DESIGN ADVISORY BOARD Tuesday, September 23, 2014 Conference Room 12, City Hall, Burlington, VT AGENDA

To: The Design Advisory Board
From: Mary O'Neil, AICP, Senior Planner *mo*
RE: ZP 15-0079CA
Date: September 23, 2014

To: The Design Advisory Board
From: Mary O'Neil, AICP, Senior Planner
RE: ZP 15-0254CA; 434-436 South Winooski Avenue
Date: September 23, 2014

Scale: 1 inch= 10 Ft.

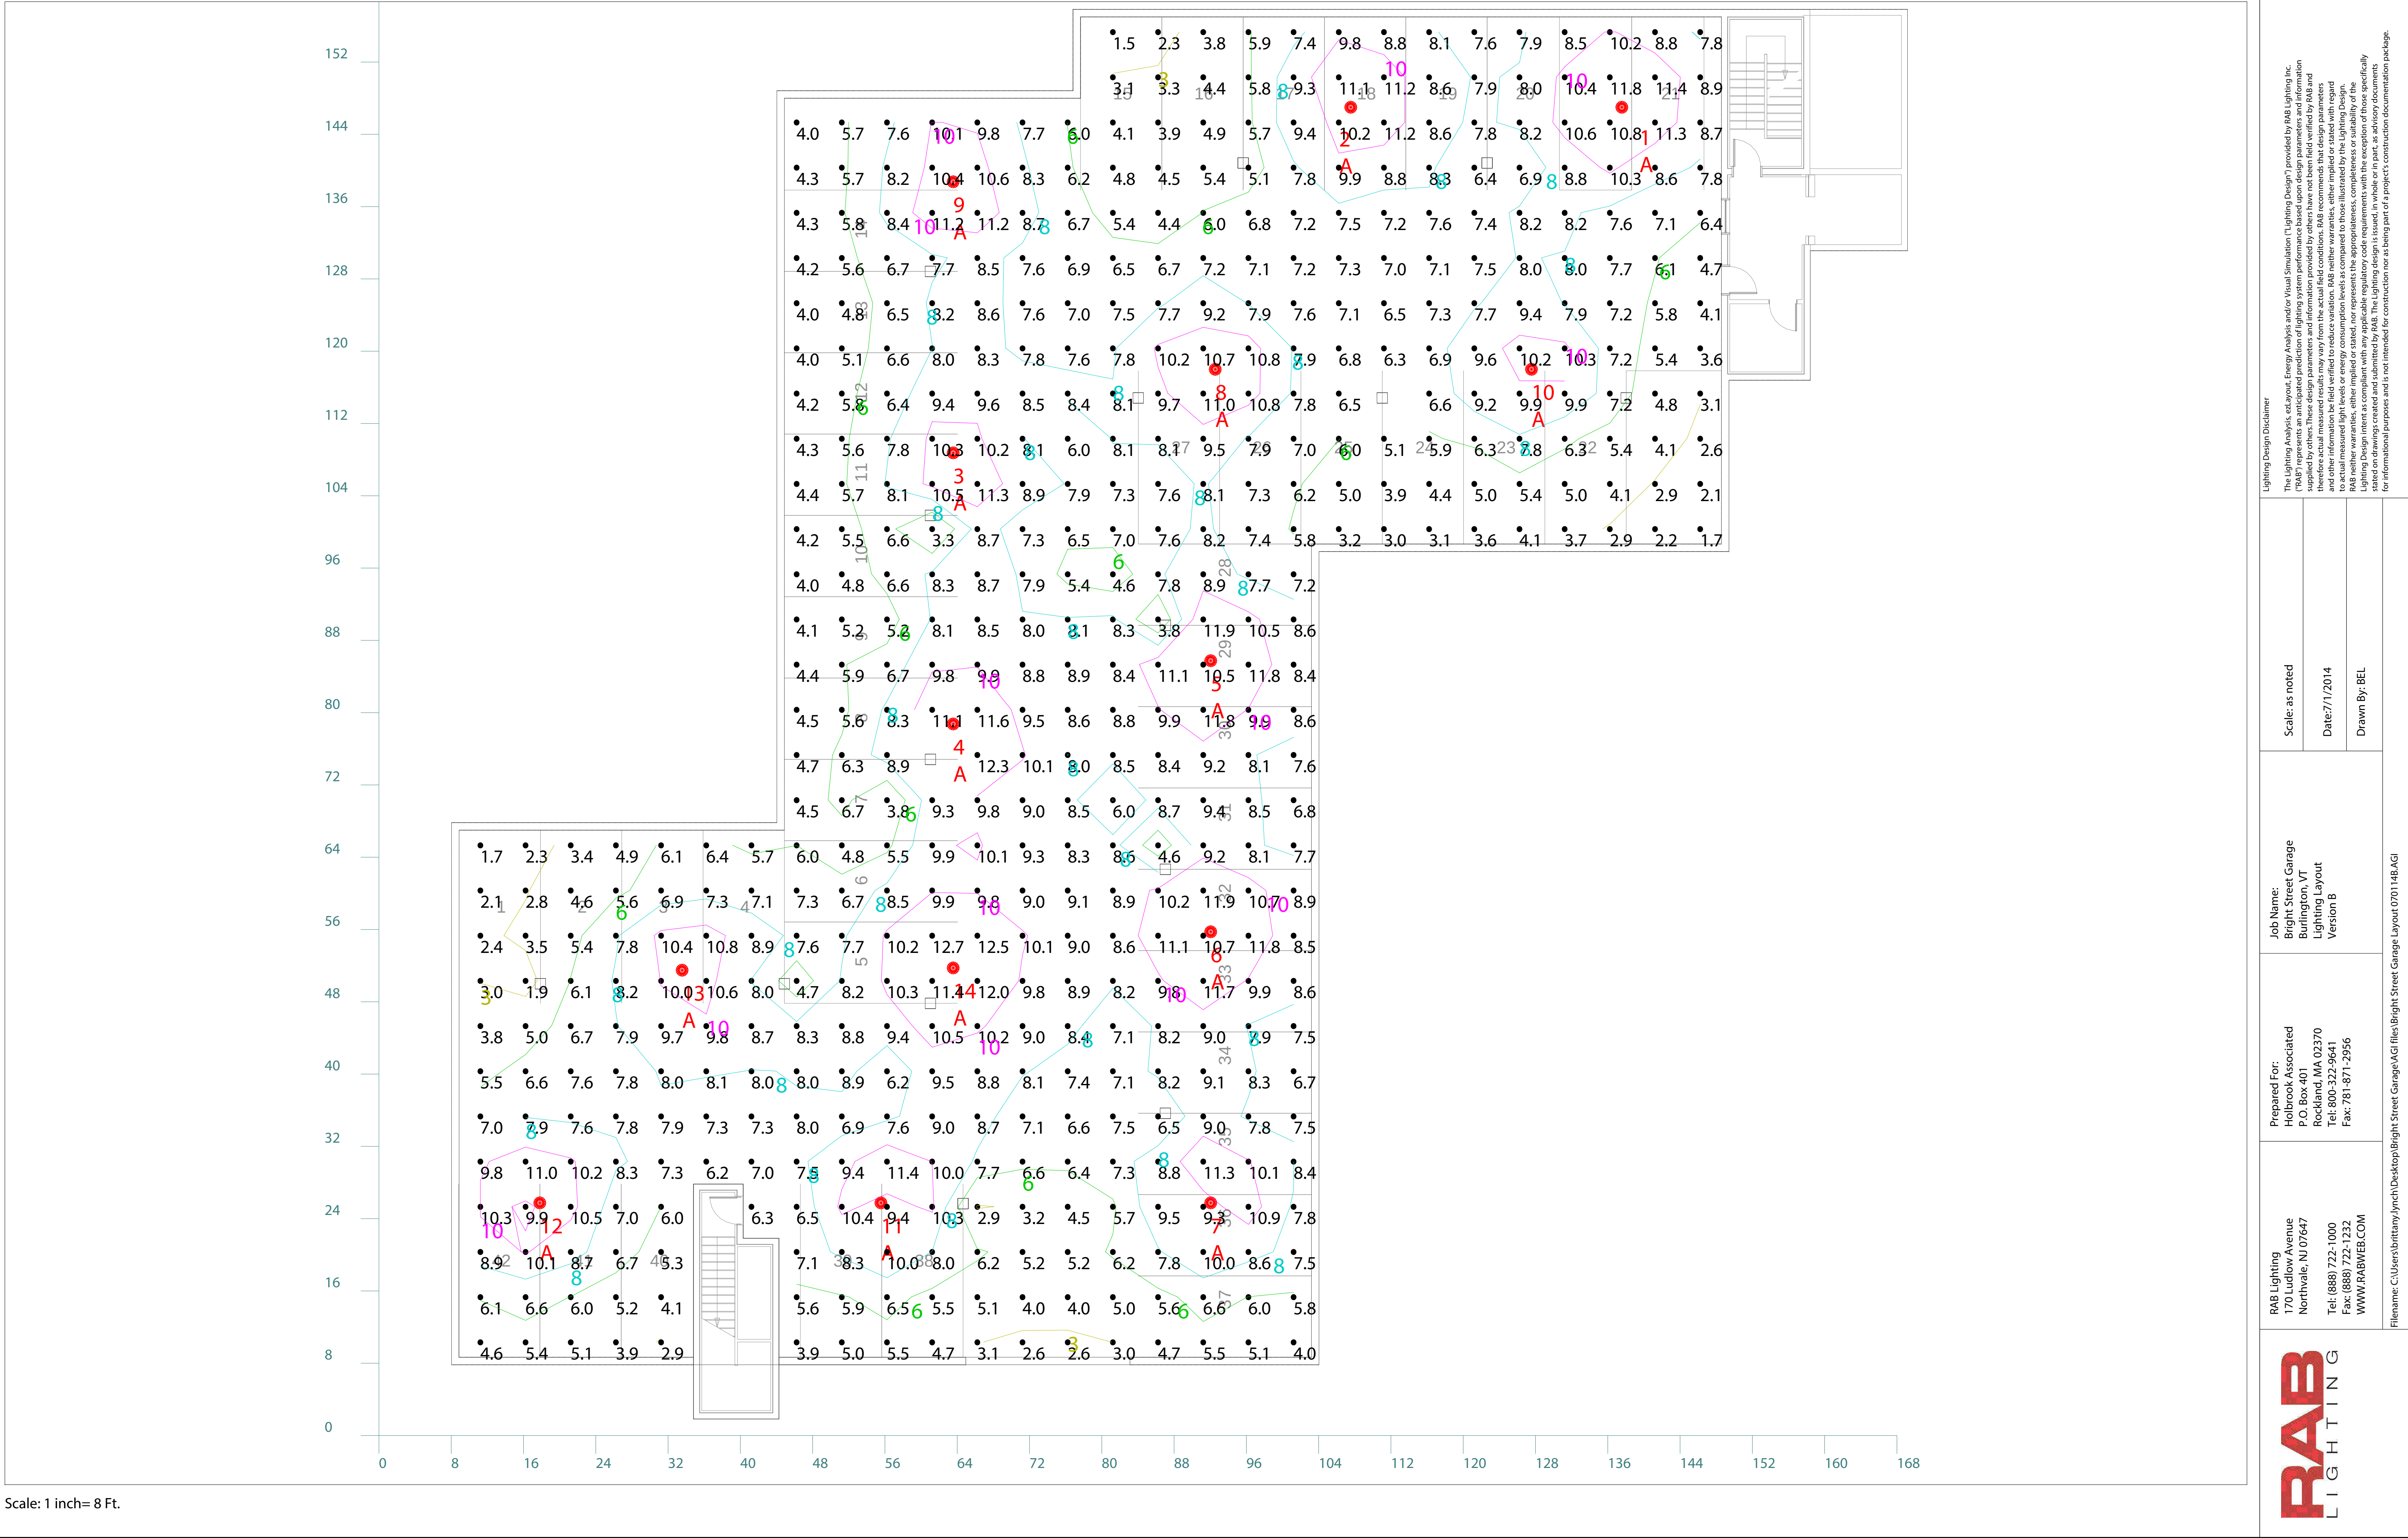
Lighting at building entrances exceeds standards of the ***Outdoor Lighting Manual for Vermont Municipalities***, Table 2, p. 10: *Building Entry – active use, 5 footcandles average maintained.* Measurements on the lighting plan illustrate entryway lighting between 5.1 fc (duplex 2 on Archibald Street) to 8.7 fc (Trinityeast entrance.) All building entrances exceed the 5 footcandle limitation, and will require revision to meet these standards, or confirmation that the average maintained level meets the standard.

3. Lighting at building entrances exceeds standards of the ***Outdoor Lighting Manual for Vermont Municipalities***, Table 2, p. 10: *Building Entry – active use, 5 footcandles average maintained*. Measurements on the lighting plan illustrate entryway lighting between 5.1 fc (duplex 2 on Archibald Street) to 8.7 fc (Trinityeast entrance.) All building entrances exceed the 5 footcandle limitation, and will require revision to meet these standards, or confirmation that the average maintained level meets the standard.
